Re: Harold D. Thompson Regional Water Reclamation Facility (HDTRWRF)
Lower Fountain Metropolitan Sewage Disposal District (LFMSDD)

Submittal No.:	03200-004B
Date of Submittal:	September 21, 2011
Title:	Headworks Building Substructure Wall and Slab Reinforcing, Submittal Drawings P5 through P12A
Specification Section:	03200
Manufacturer:	Dalco Industries, Inc.

The referenced submittal has been stamped "**Make Corrections Noted**". Our comments are as follows:

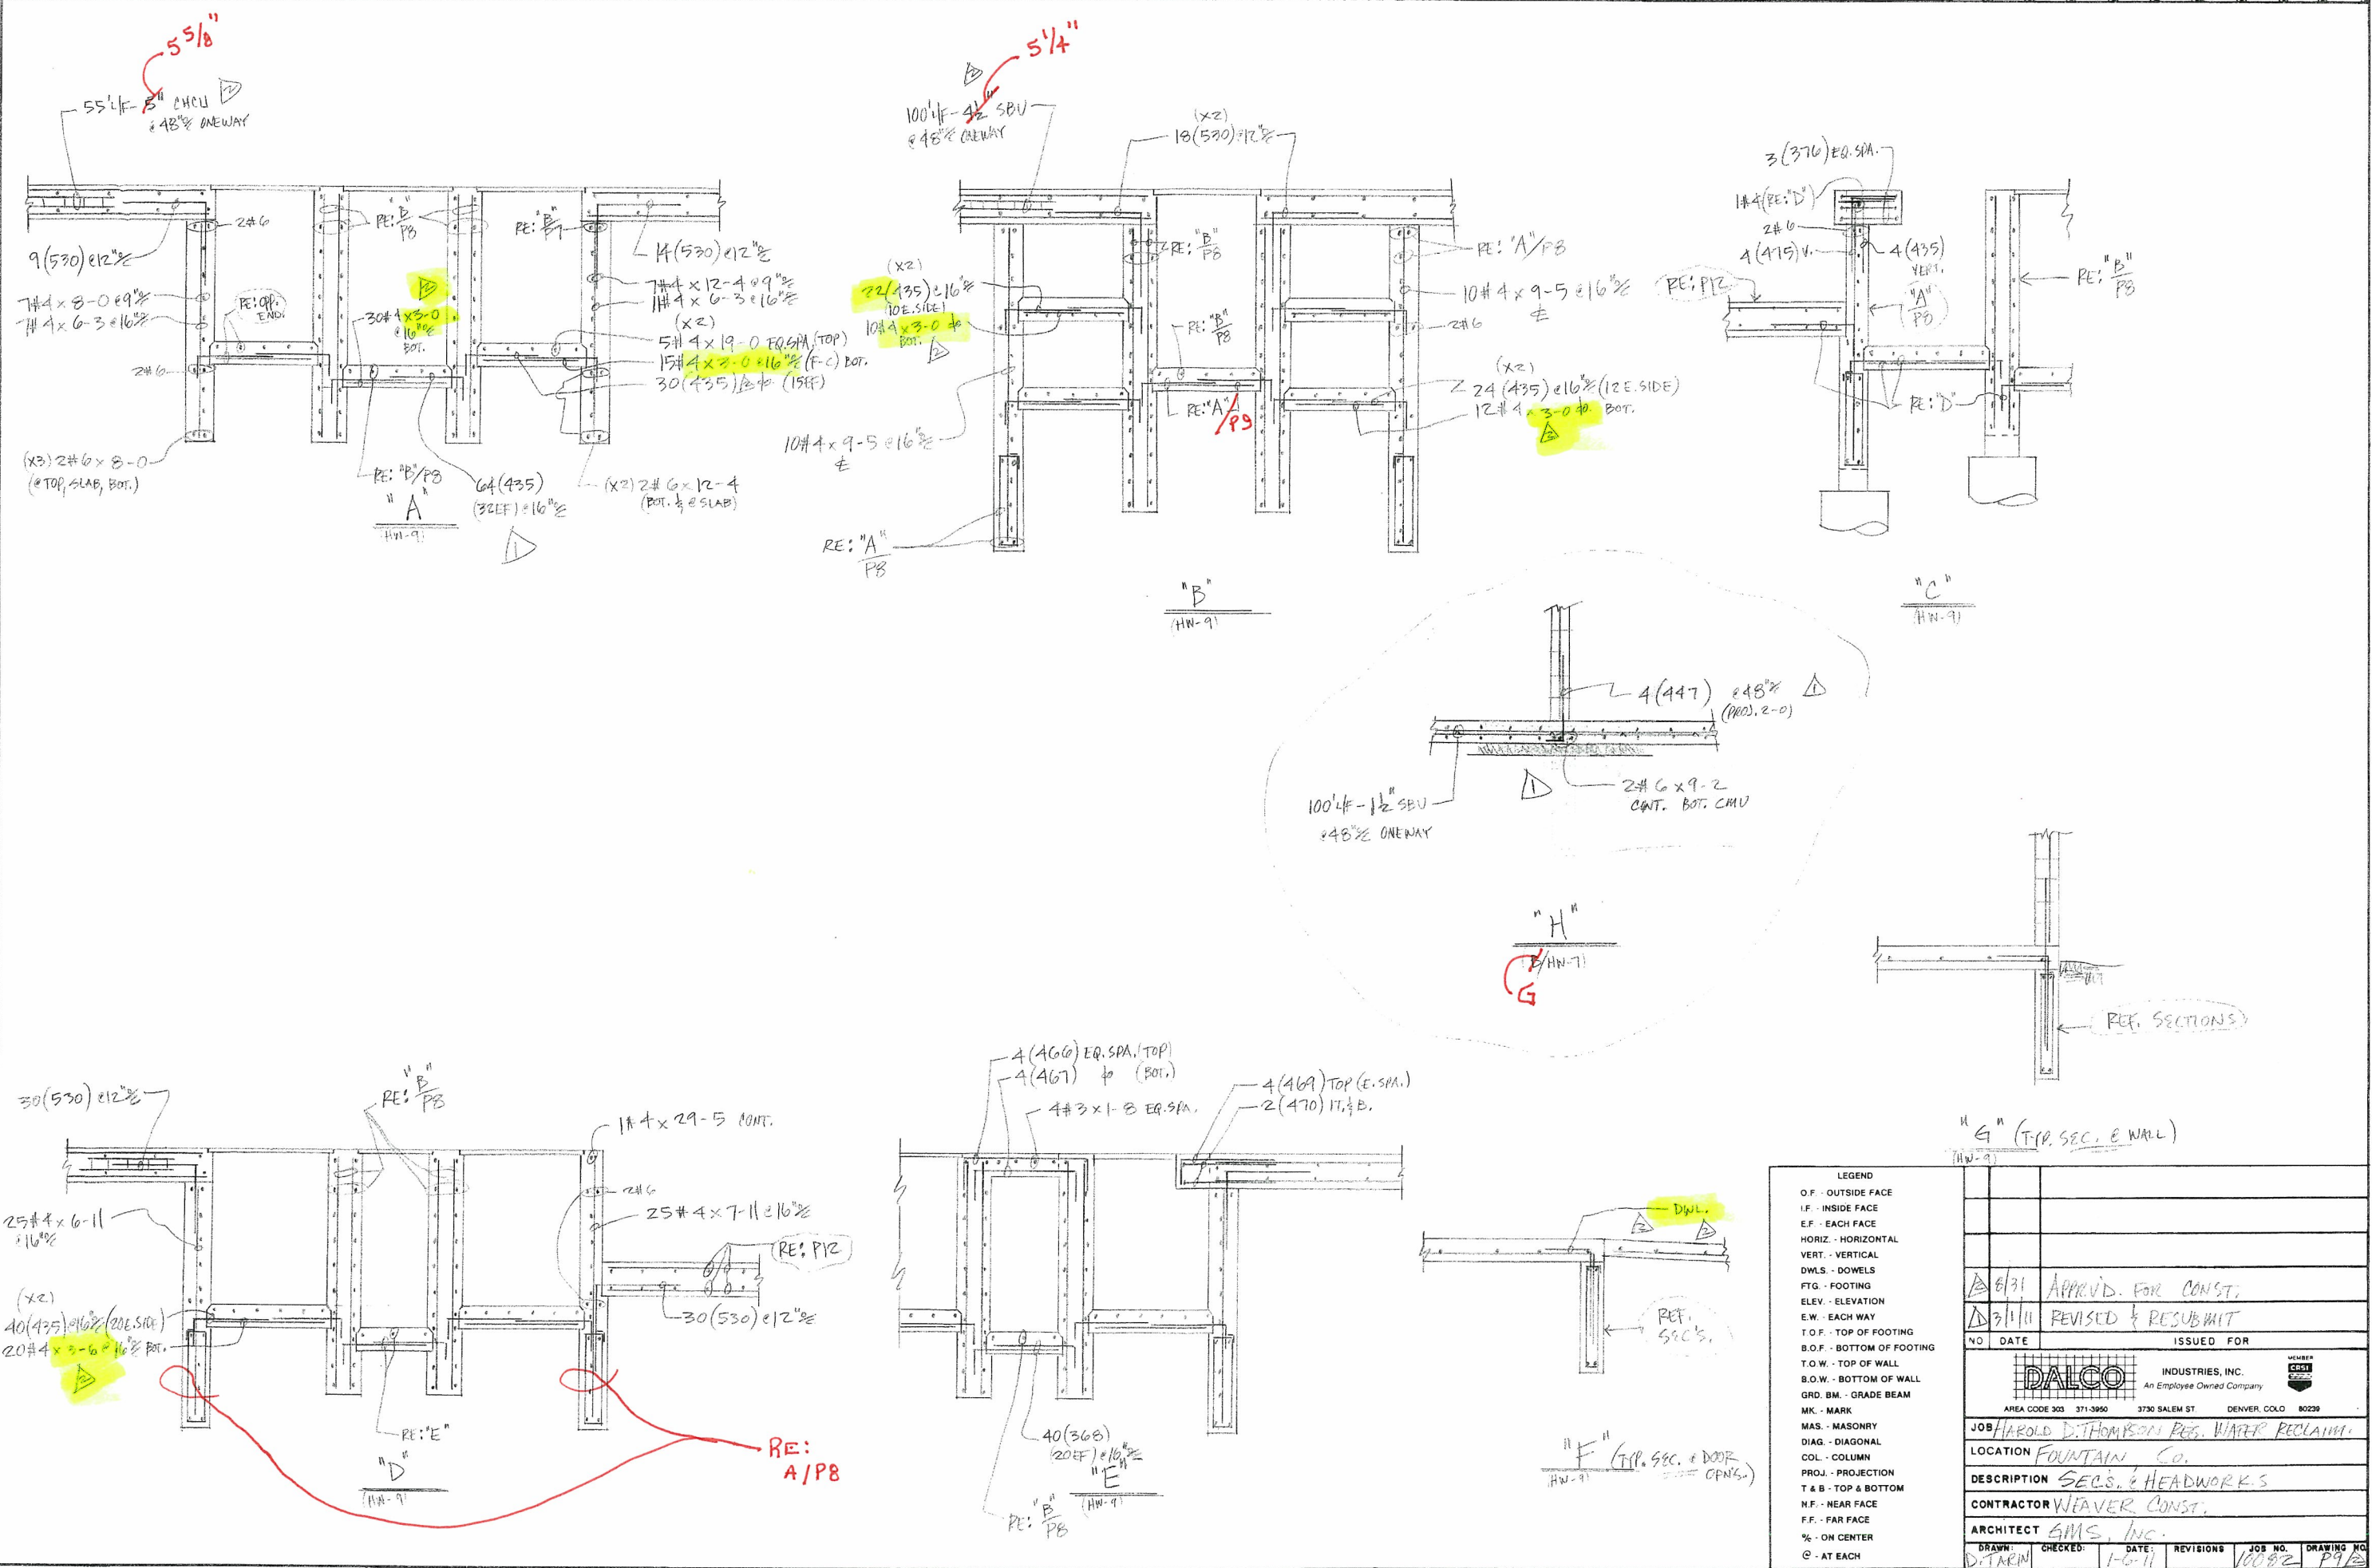
1. Attached please find a highlighted and redlined set of markups of the submitted documents. The highlighted items have been satisfactorily addressed. Those that have been redlined are items that were not satisfactorily addressed per the redlined drawings returned with shop submittal response correspondence dated June 15, 2011.
2. We request all corrections be made as redlined on the attached drawings. The Contractor shall ensure all rebar has been fabricated correctly upon delivery to site and the corresponding reinforcing bar installed in accordance with the redlined drawings as returned on June 15, 2011 and attached to this letter.

SLAB PLAN

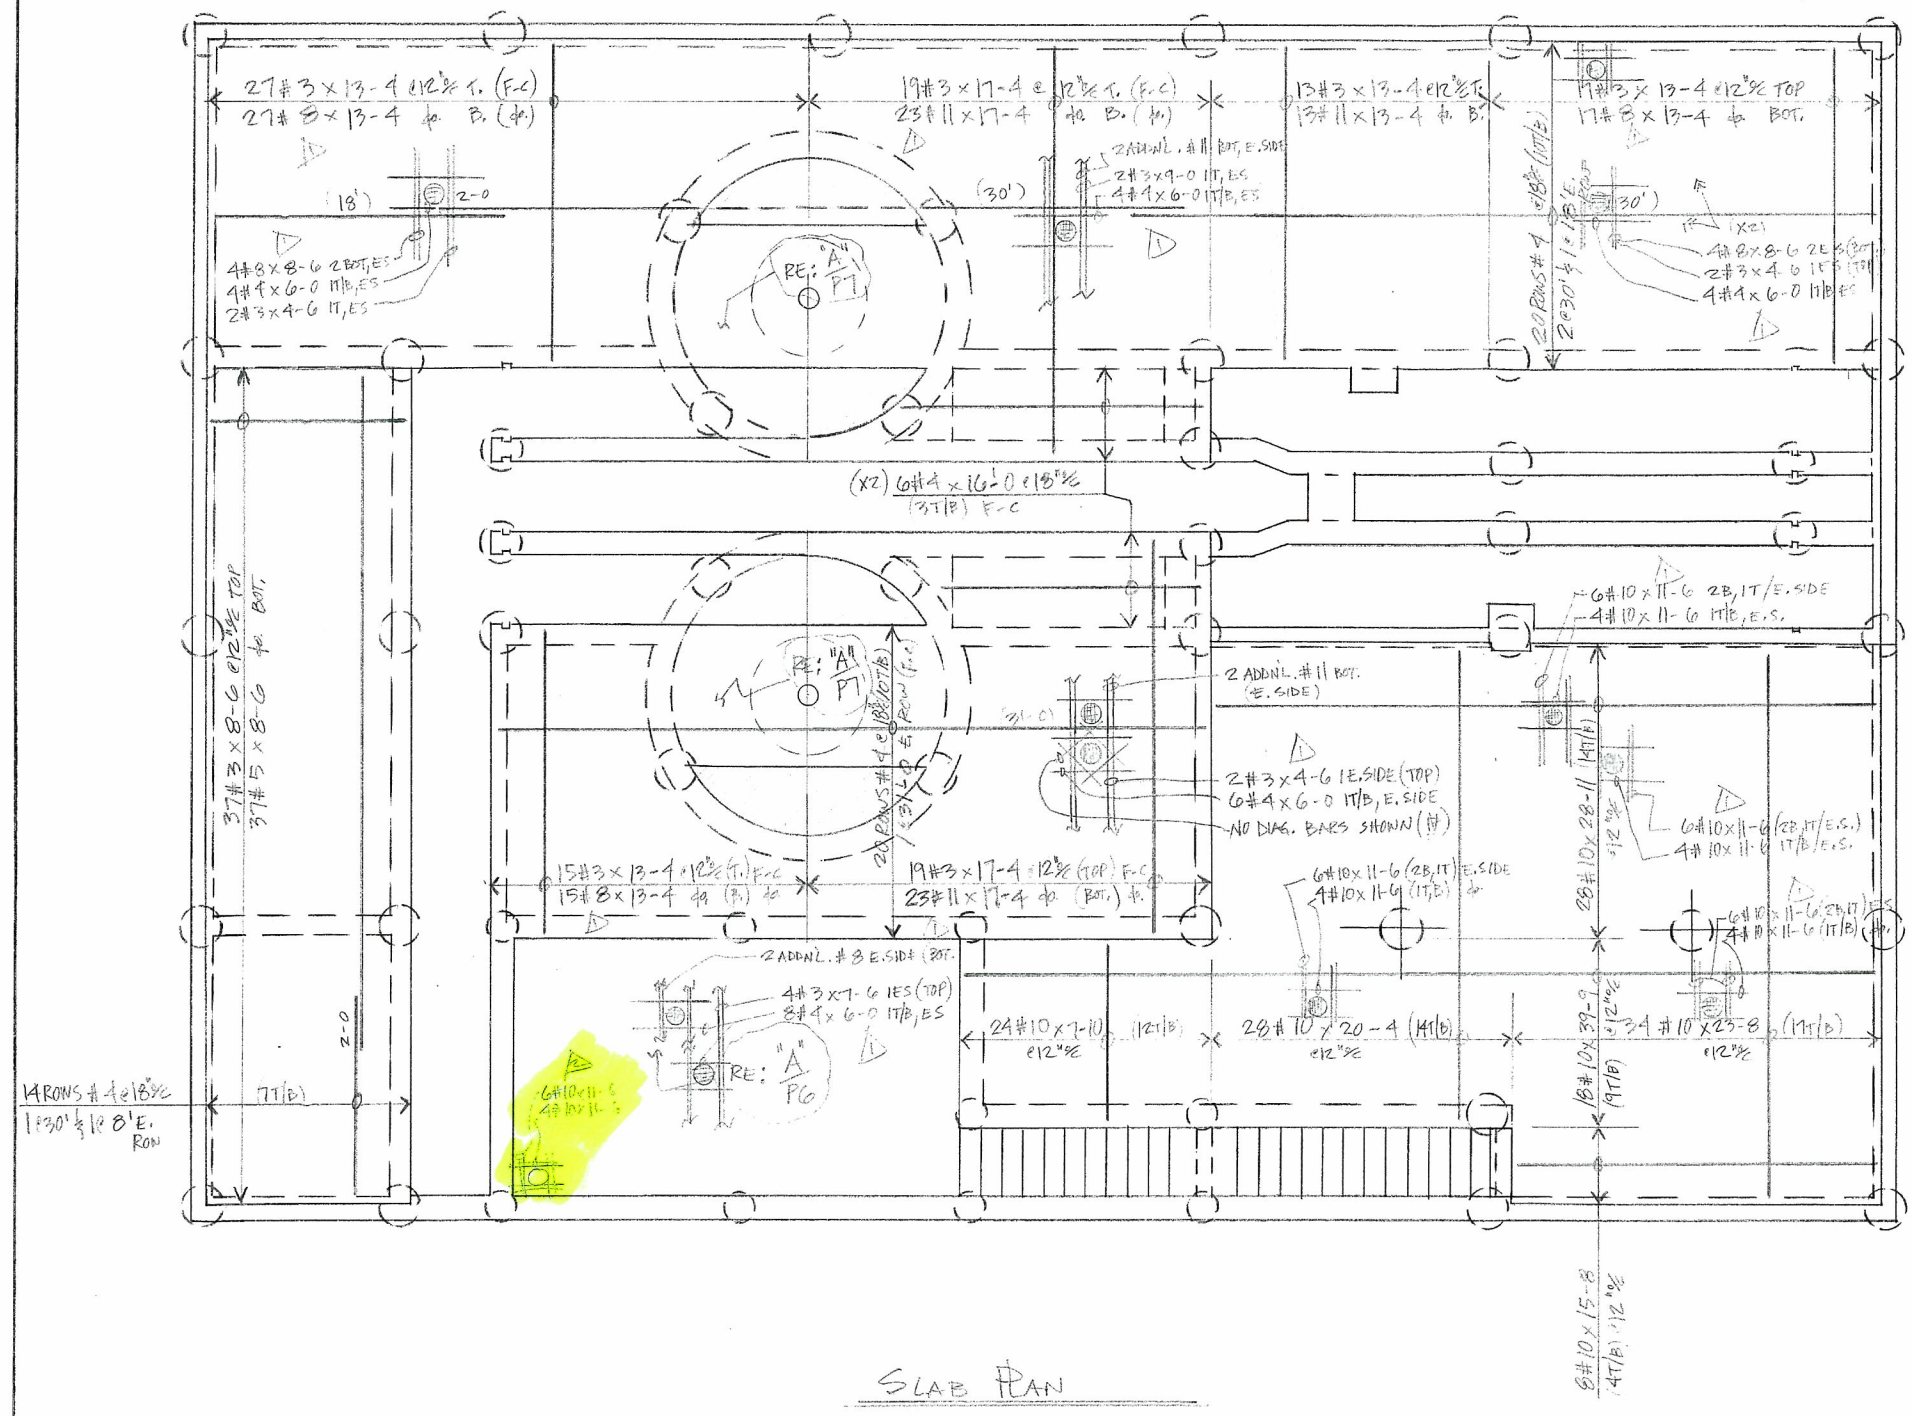
PROVIDE FULL LENGTH
#5, #8 & #11 BOT.
SLAB BARS - DO NOT
SPICE

REF. WALL SECTIONS
FOR BAR CHAIRS
BTWN. WALLS...
(TYP.)

DRAIN PIPE ENCASEMENT PLAN
NTS

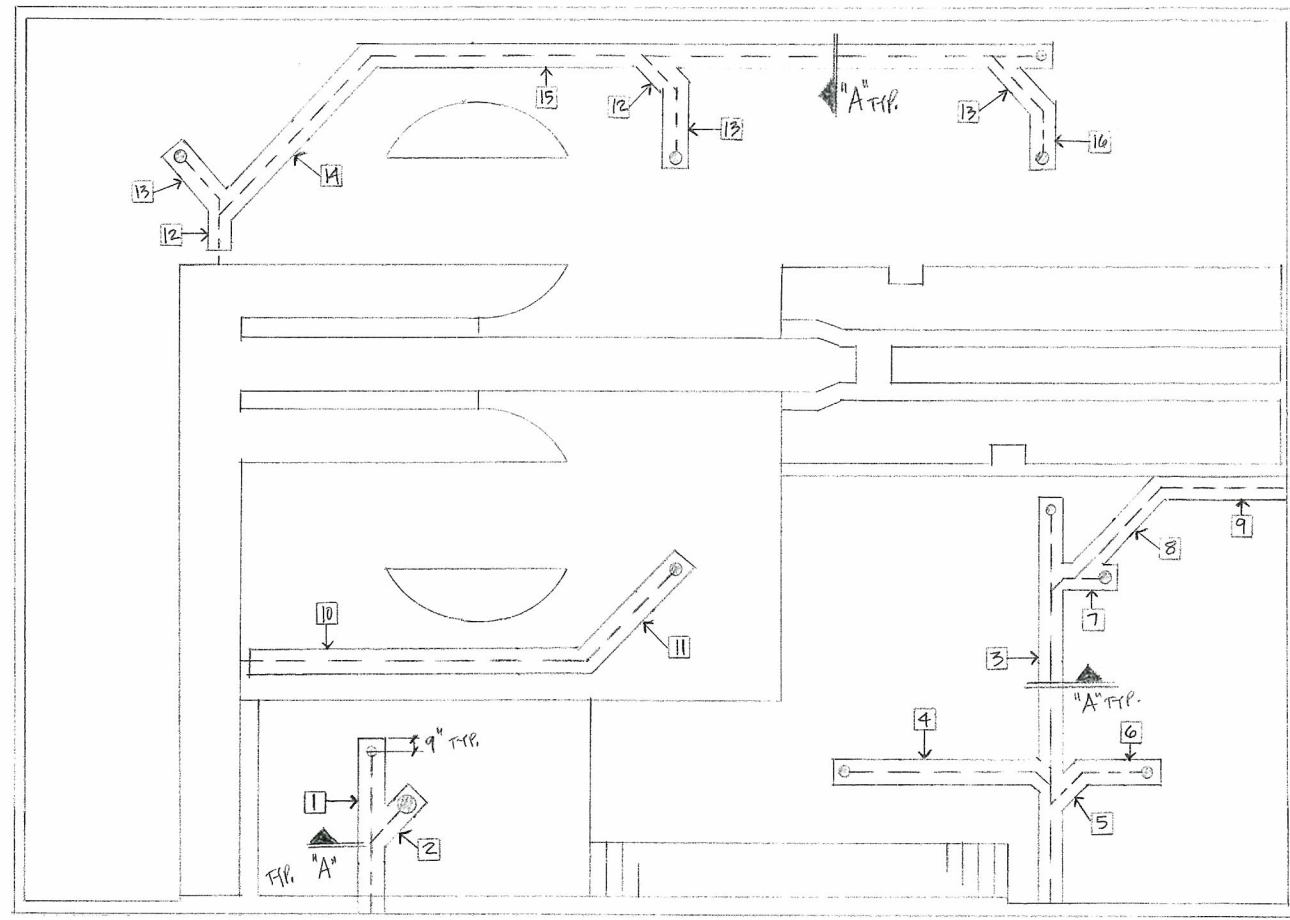
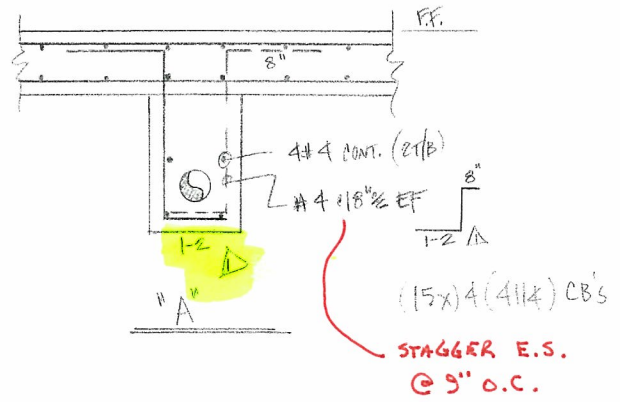
REF: A/HW-18 9 1/2 ID / DL-4 FOR
ADD'L. ENCASED PIPING FROM GRIT
CHAMBERS TO PUMP ROOM.

REF: A/HW-18 FOR ADD'L. GRADE
BEAM TO SUPPORT ENCASEMENTS
